# CITY OF ALBUQUERQUE

**RE: 4741 Pan American Fwy NE  
Conceptual Grading & Drainage Plan  
Engineer's Stamp Date: 01/09/26  
Hydrology File: F16D019  
Case # HYDR-2026-00008**

**CONCEPTUAL GRADING PLAN**

CG-101

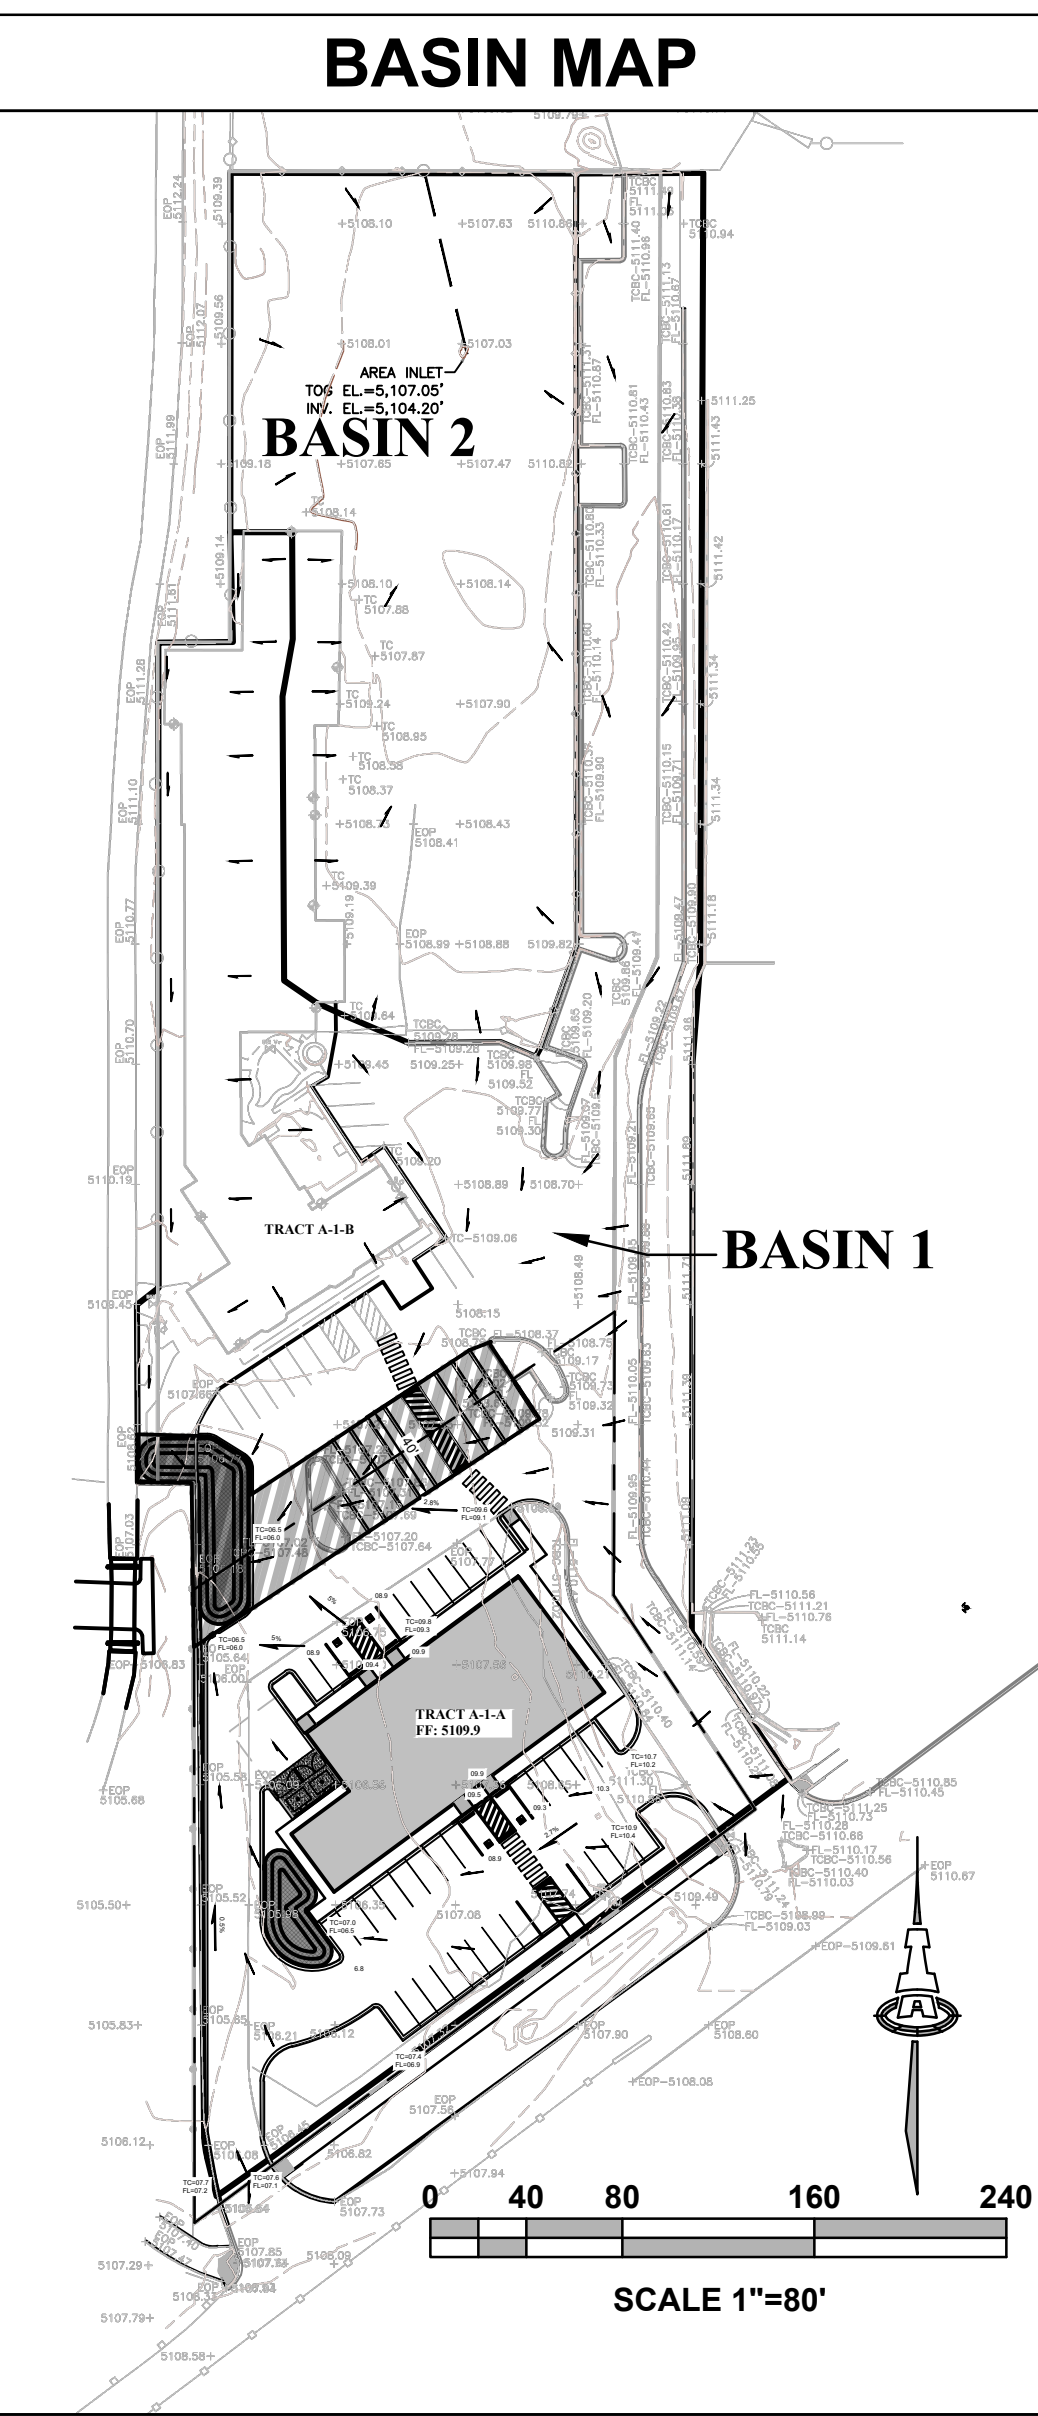
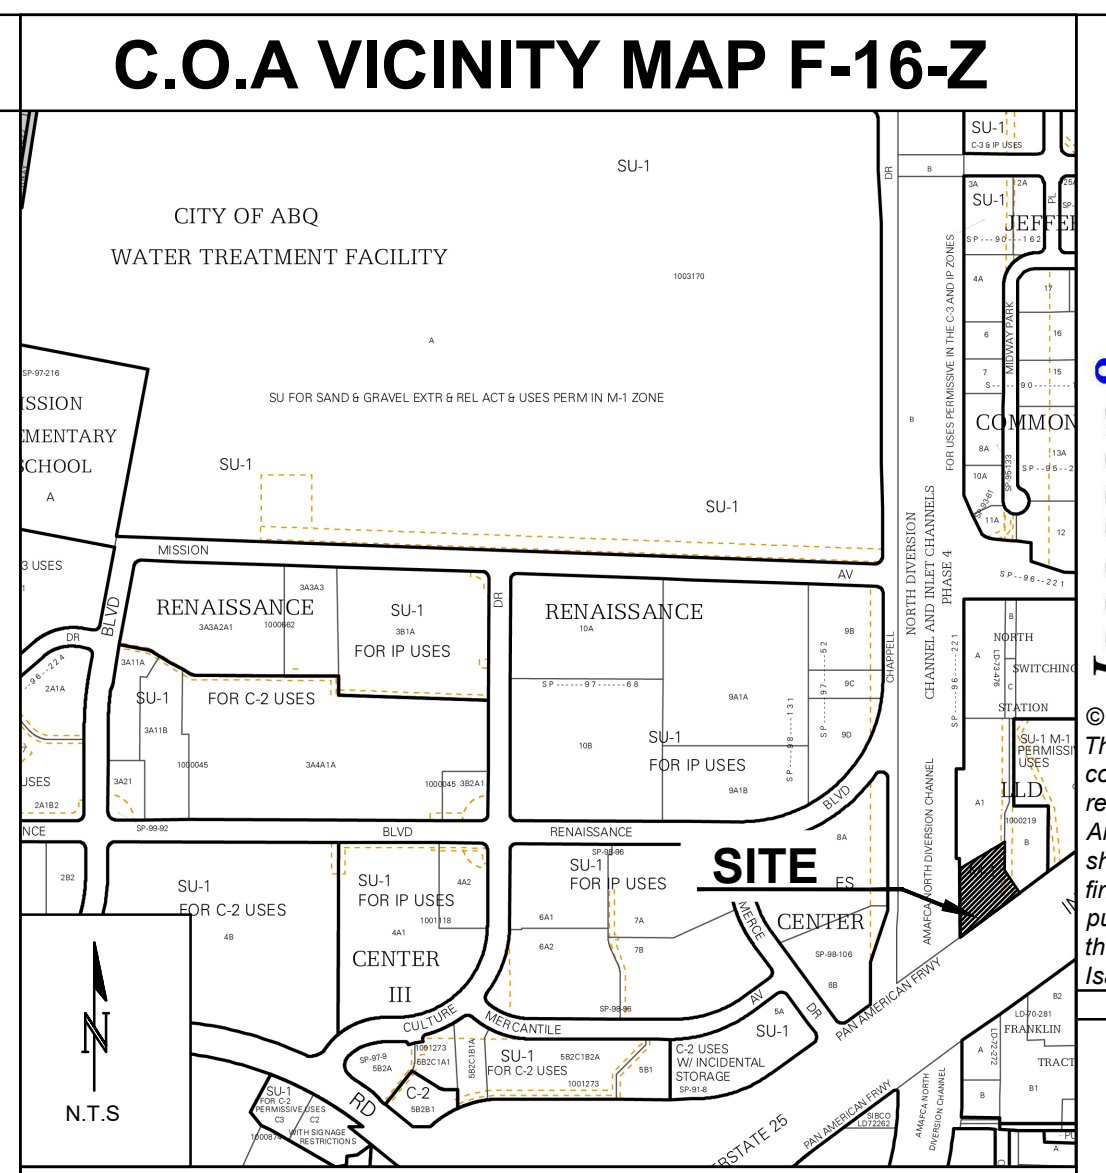
Based upon the information provided in your submittal received 01/09/2026, the Conceptual Grading & Drainage Plan **is approved** for action by the Development Facilitation Team (DFT) on Site Plan for Building Permit or for action by the Development Hearing Officer (DHO) on Preliminary Plat.

1. Please submit a more detailed Grading & Drainage Plan to Hydrology for review and approval.
